UNITED STATES  
NUCLEAR REGULATORY COMMISSION  
WASHINGTON, D.C. 20555

OPINION OF COMMISSIONERS GILINSKY AND BRADFORD ON COMMISSION  
REVIEW OF ALAB-644 (DIABLO CANYON SEISMIC PROCEEDING)

OPINION OF COMMISSIONER AHEARNE ON COMMISSION REVIEW  
OF ALAB-644 (DIABLO CANYON SEISMIC PROCEEDING)

SEPARATE VIEW OF COMMISSIONER ROBERTS

DIABLO CANYON CONTAINMENT STRUCTURE  
 COMPARISON OF VARIOUS ELASTIC RESPONSE SPECTRA

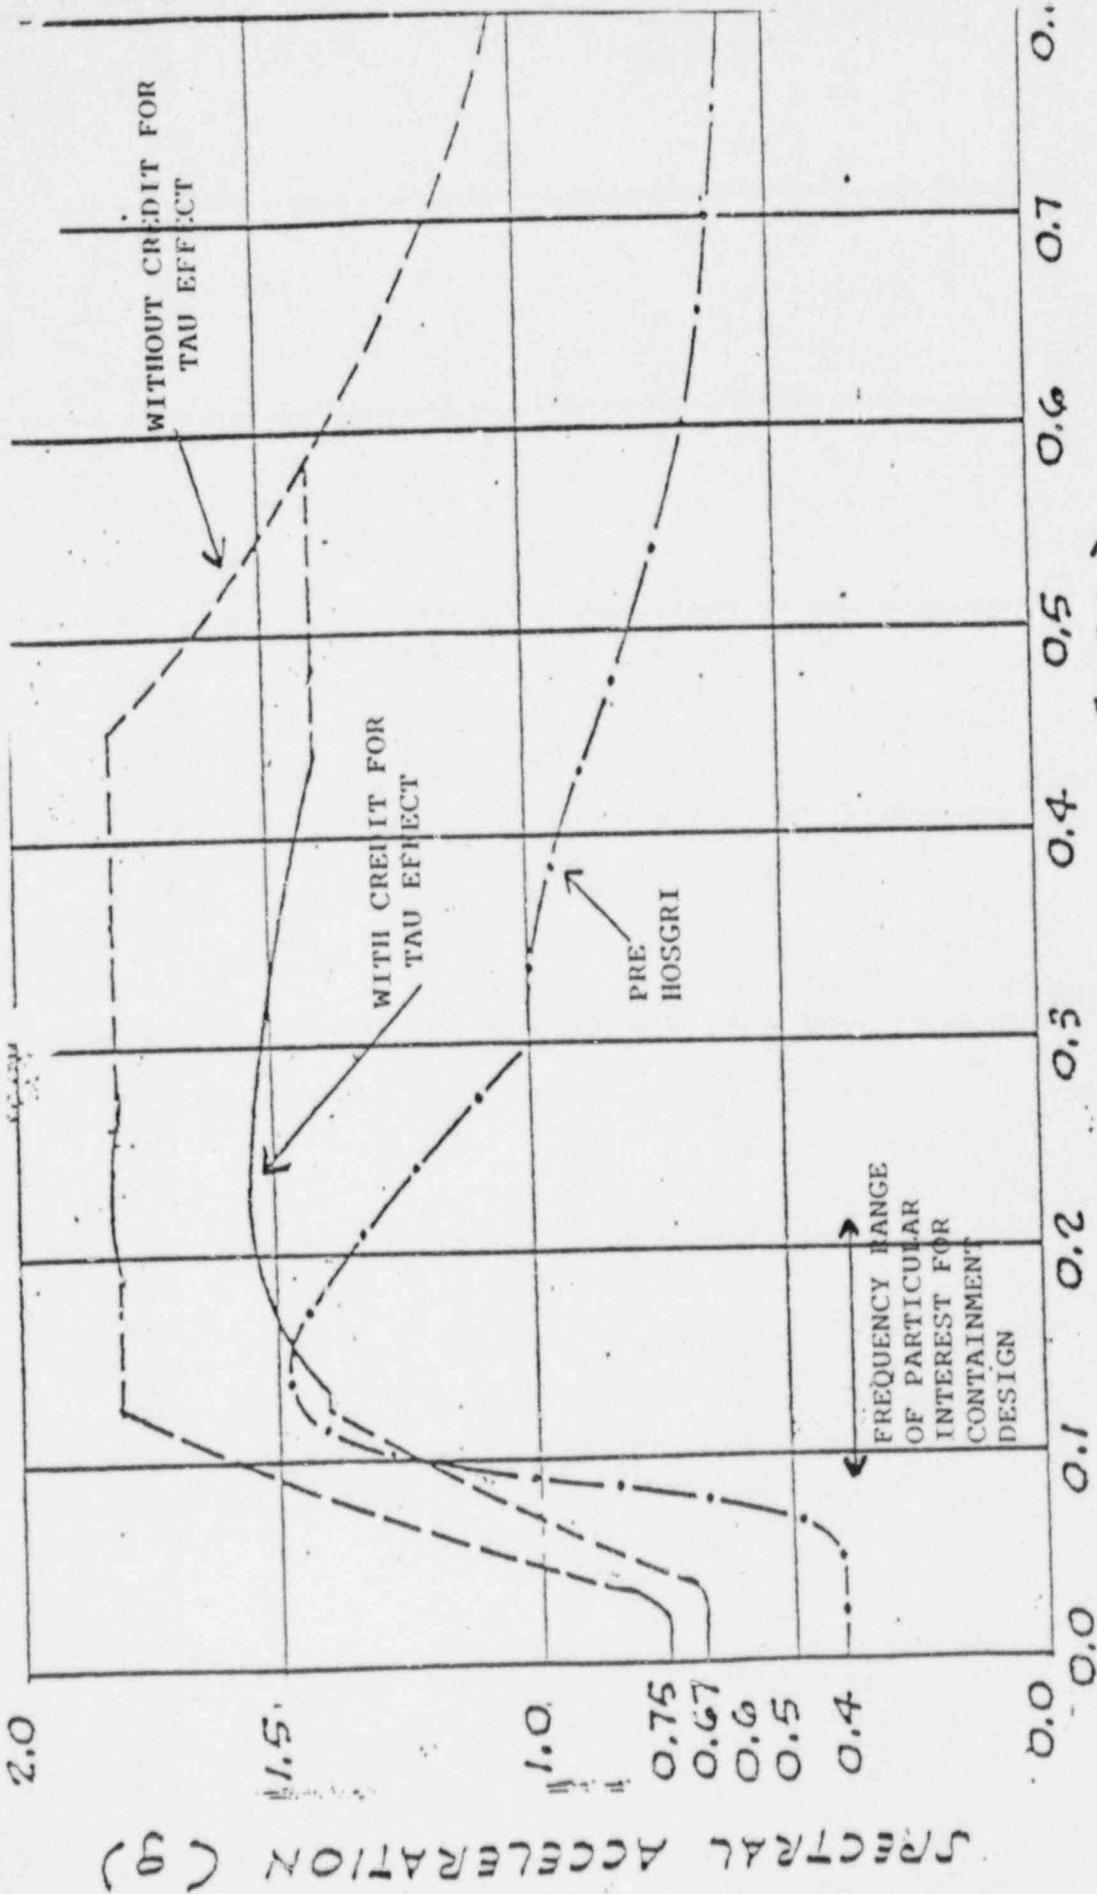
With the changes and adjustments permitted by the Board it turns out that the post-Hosgri seismic response spectrum does not in all respects represent a more severe seismic standard than the one used before the discovery of the Hosgri fault. As the accompanying diagram illustrates, in the frequency range between 5 and 10 hertz (cycles per second), a range of particular interest in the analysis of the containment building surrounding the reactor, the two response spectra are quite close.<sup>10</sup> For part of this range, in fact, the old spectrum shows a higher response. In other words, for that part of the range the original design conditions were more demanding than the new ones imposed after the discovery of the Hosgri fault. This new

spectrum is the basis of the engineering reanalysis and ultimately determined the extent to which the containment was to be modified. Not surprisingly, in view of the above, only minor changes were required in this area.
